STAFF REPORT

Case #31-17: SITE PLAN APPROVAL
61 John Vertente Boulevard
(Map 133, Lot 47)

The submittal is shown as the Site Plan for 61 John Vertente Boulevard (Assessors Map 133, Lot 47) New Bedford, MA dated August 10, 2017 prepared for Parallel Products of New England, 401 Industry Road, Louisville, KY 40208 by Farland Corp., 401 County Street, New Bedford, MA 02740, consisting of nine (9) sheets;

DATE: AUGUST 10, 2017
SCALE: 1"=50'
JOB NO. 17-413
LATEST REVISION:
EROSION & SEDIMENT CONTROL PLAN
SHEET 6 OF 9

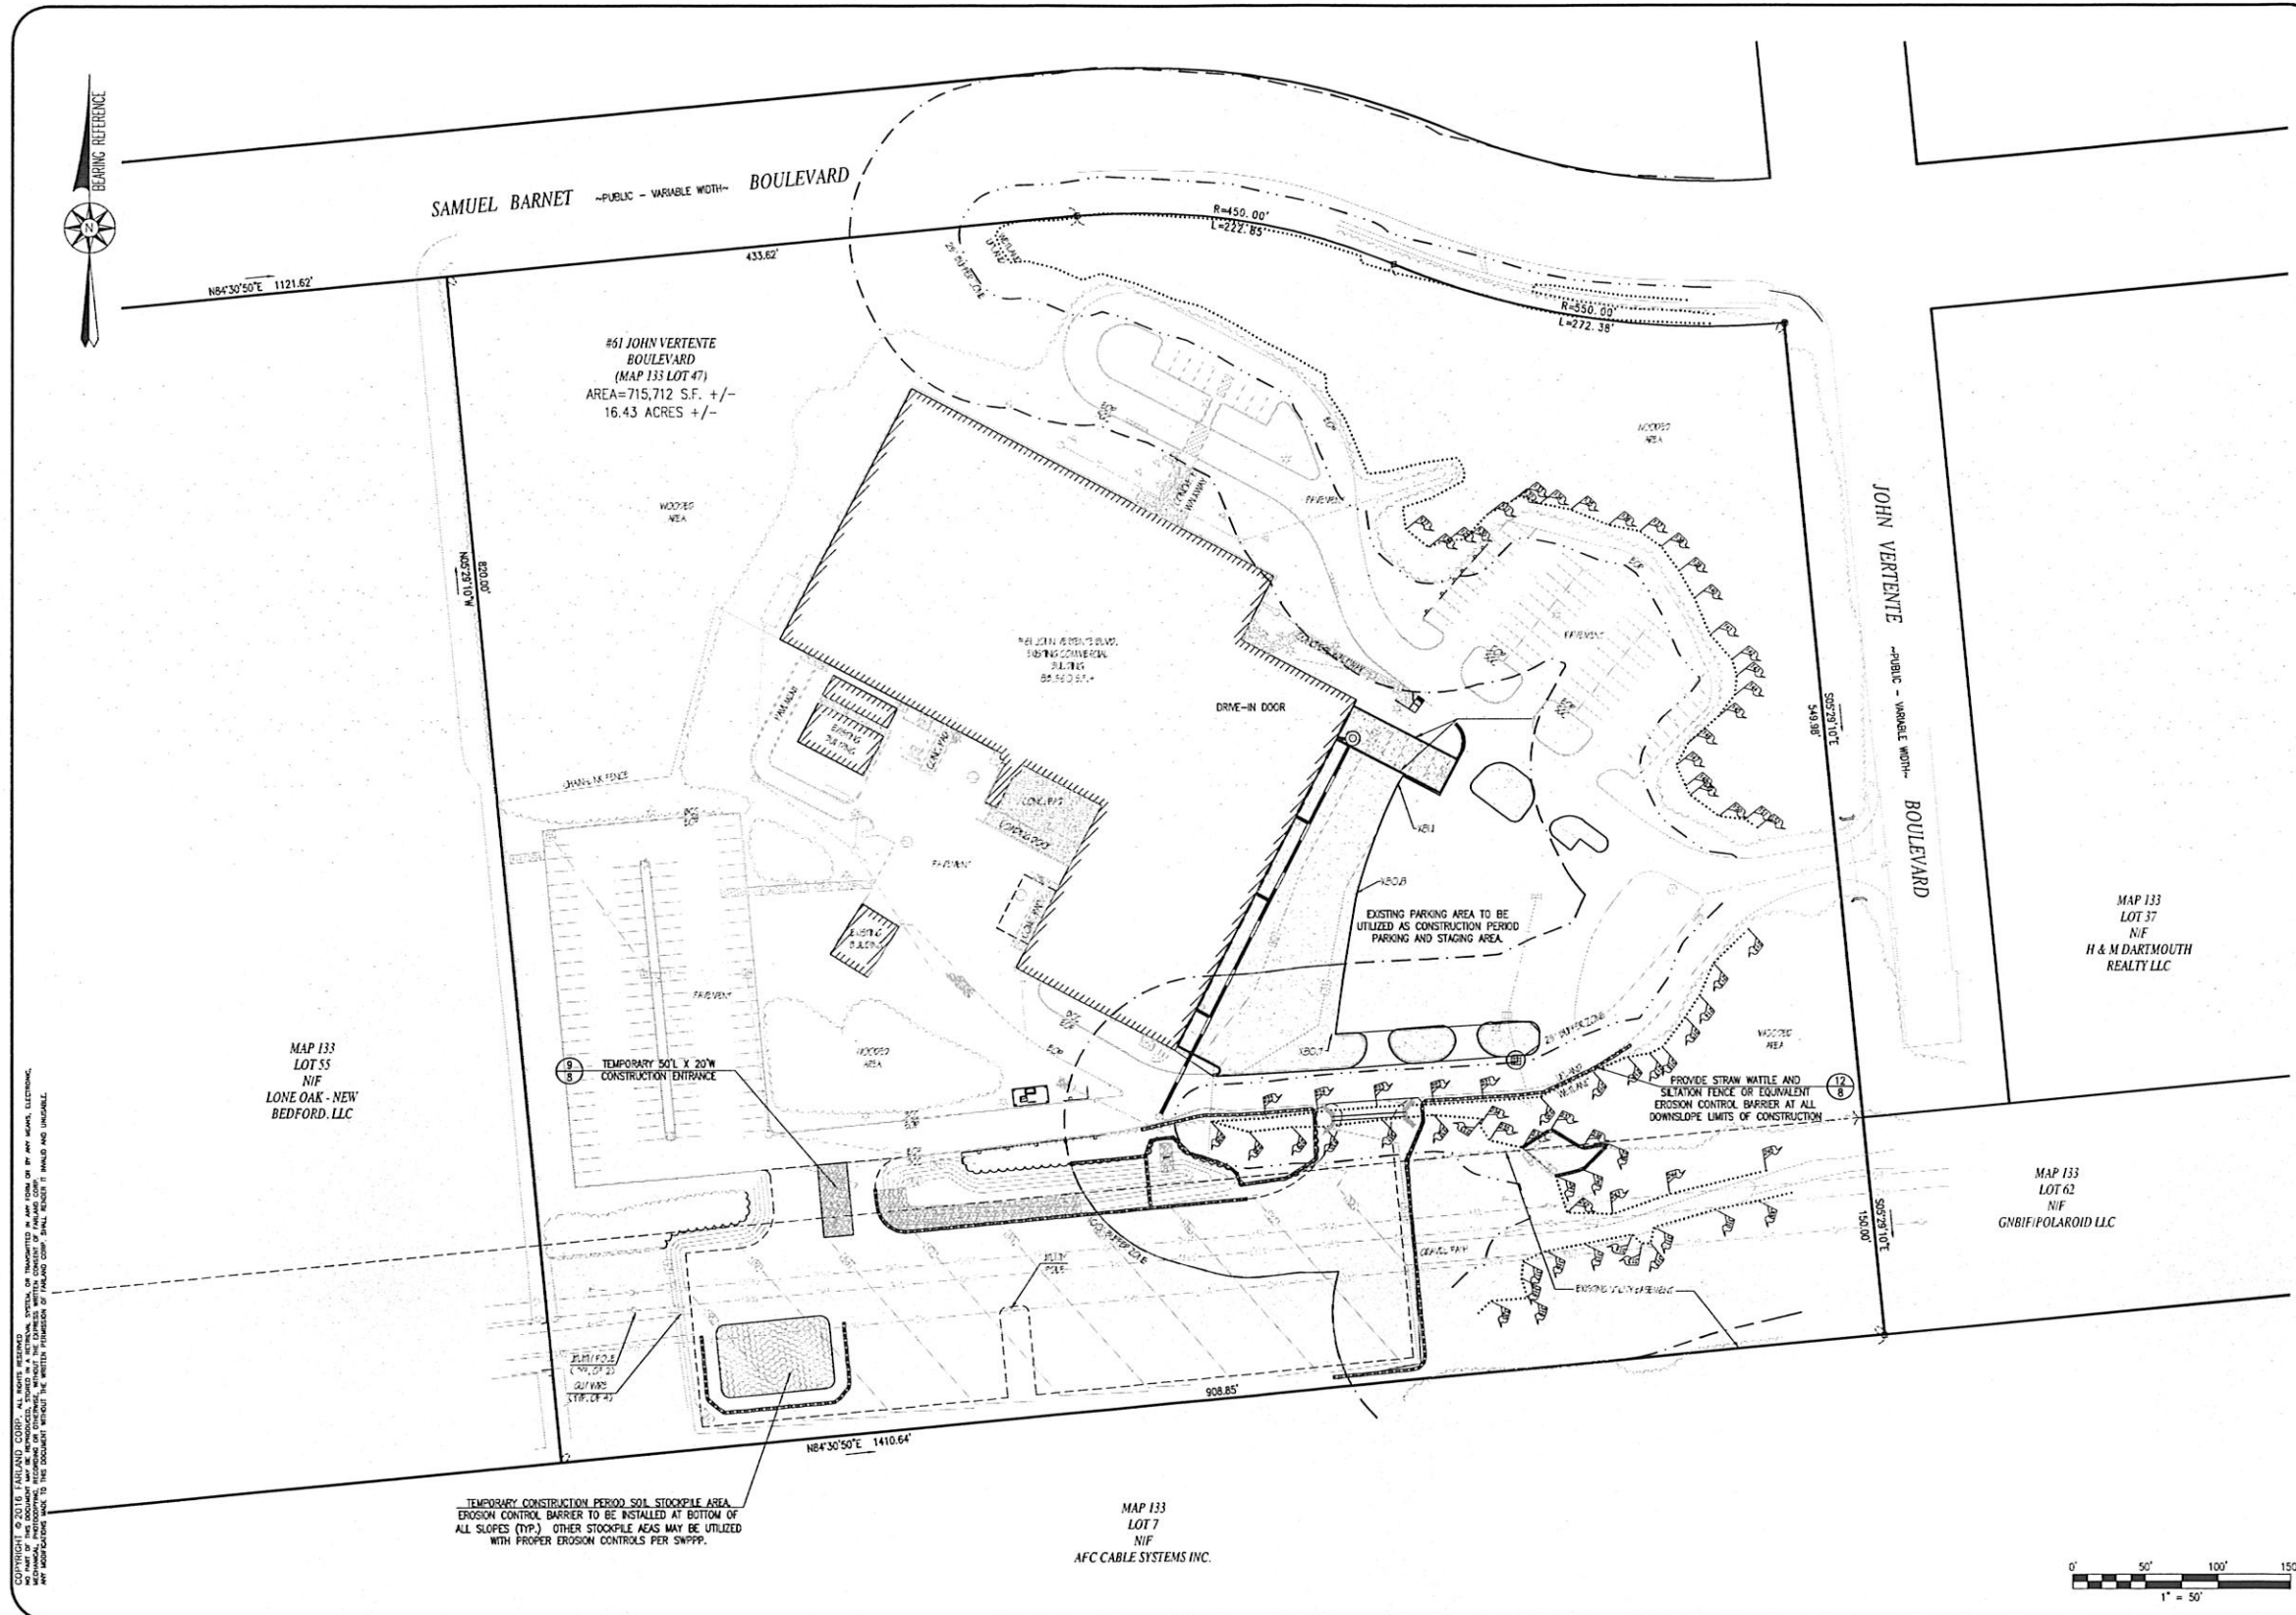
- **Erosion & Sediment Control Plan-6 of 9**
 - ☐ Staff defers to the forthcoming Department of Public Infrastructure memo and Conservation Commission peer review (Attachment 10).

DETAIL SHEET
SHEET 8 OF 9

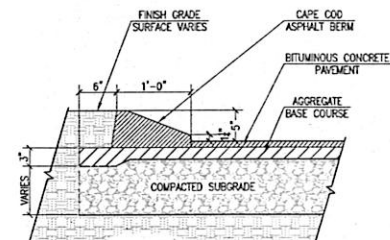
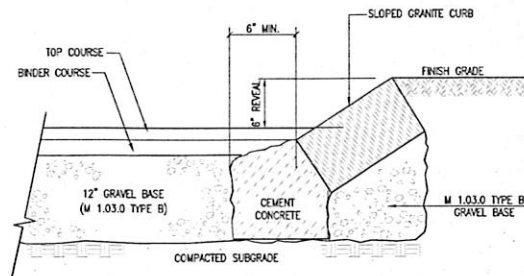
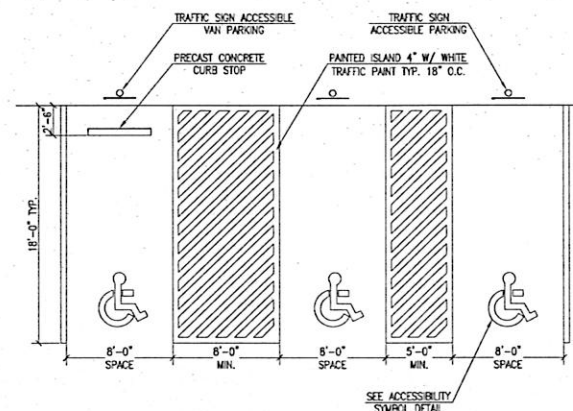
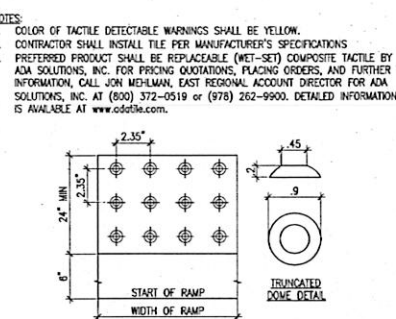
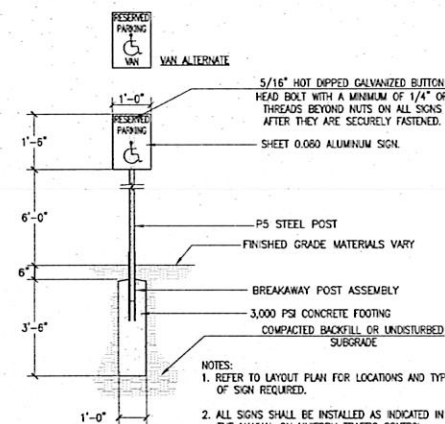
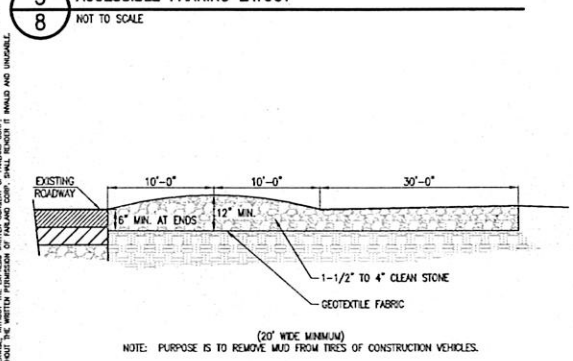
- **Detail Sheet- Sheet 8 of 9**
 - ☐ Change Hay bales/Hay to Straw bales/Straw where applicable.
 - ☐ Staff defers to the Department of Public Infrastructure and Conservation Commission peer review (Attachment).
